Request for LOMR

Villages at Sierra Ranch

06-09-B002P

RE: Request for Letter of Map Revision
Villages at Sierra Ranch, City of North Las Vegas, Nevada
CNLV: 14376 Stanley Job #: 17619
FEMA Case No.: 06-09-B002P

MAP NUMBER
32003C1769 E
MAP REVISED:
SEPTEMBER 27, 2002

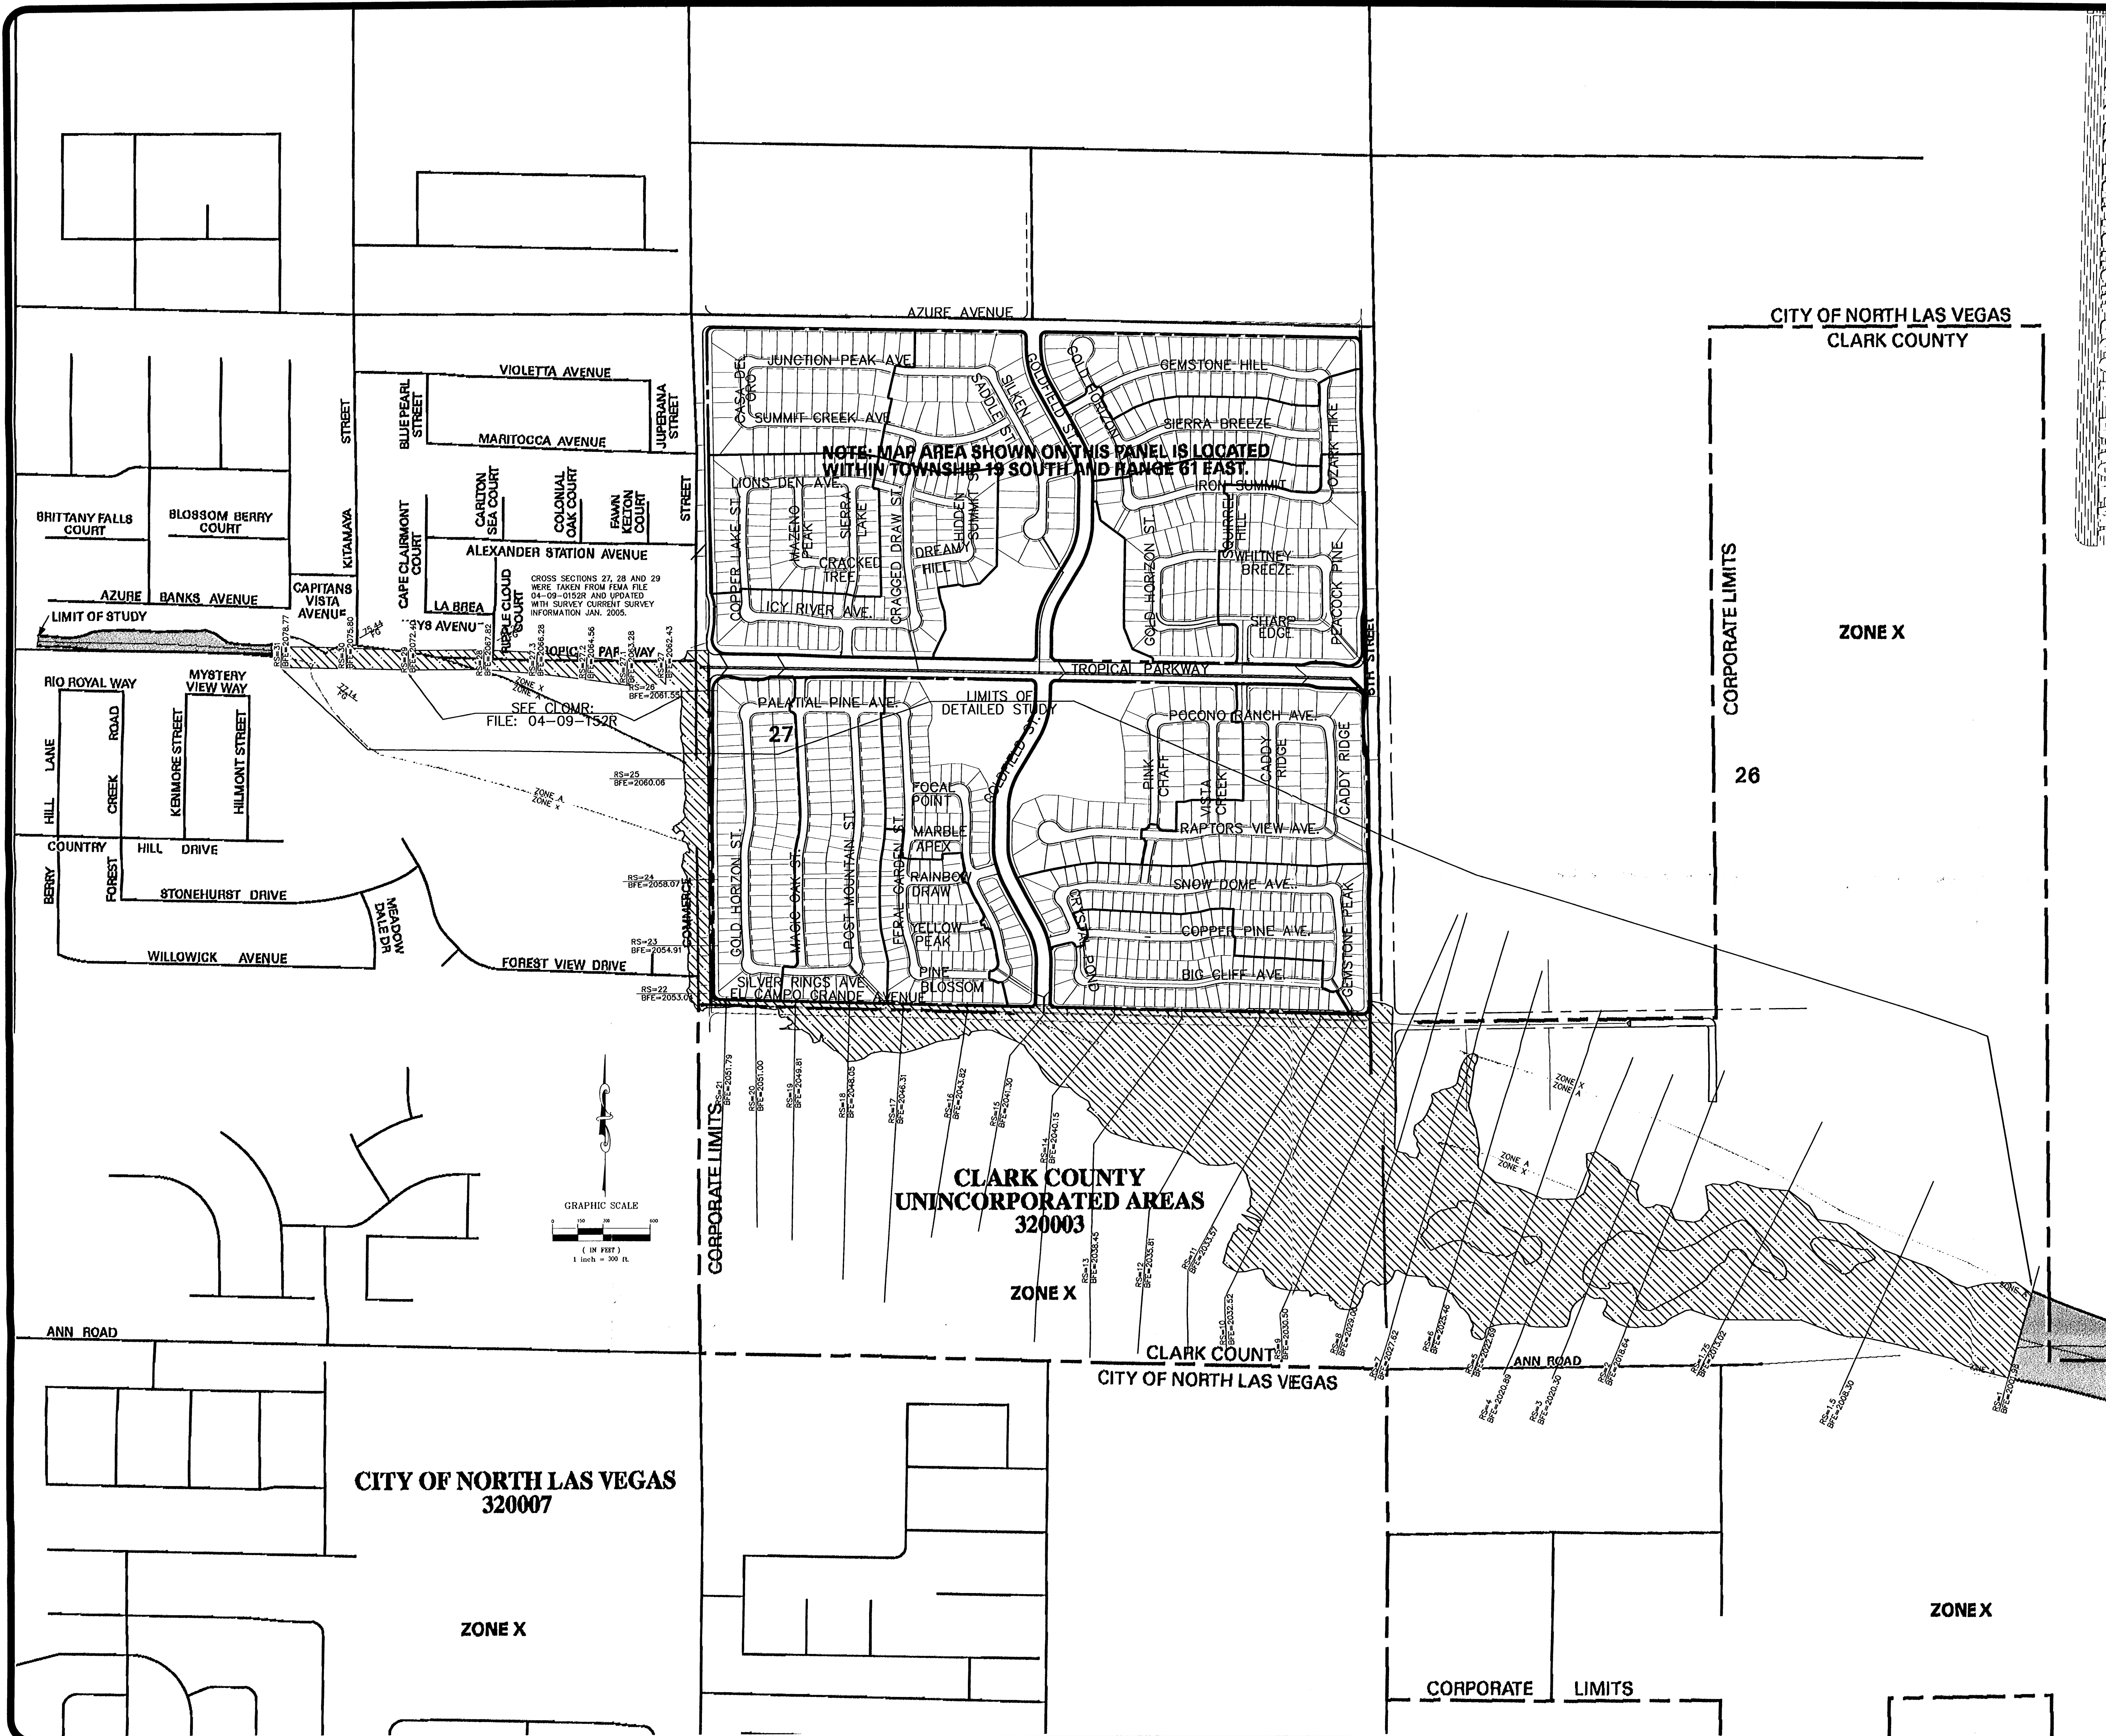
Comment 3: Because the LOMR request for the Villages at Sierra Ranch development has been submitted before the LOMR for Case No. 04-09-0152R, the revised boundary delineations of the Special Flood Hazard Area (SFHA), the area that would be inundated by the flood having a 1-percent chance of being equaled or exceeded in any given year (base flood), must tie into the currently effective SFHA boundary delineations. Please submit a hydraulic model and a topographic map, certified by a registered professional engineer, in which the revised SFHA boundary delineations tie into the currently effective SFHA boundary delineations at the upstream end of the revision.

Response 3. Additional survey was obtained along Tropical Parkway and around the existing elementary and middle schools showing the improvements since the aerial photography was taken. Additional sections, 31, 30, 27.3, 27.2 and 27.1 were interpolated from the survey information. Sections 29, 28 and 27 within the CLOMR, Case No. 04-09-0152R were updated to reflect the surveyed sections. A lateral weir was placed on the right bank to reflect field conditions. The results show the water surface remains within the roadway. The resulting HEC-RAS model, topographic maps and updated annotated FIRM Map are included for your review.
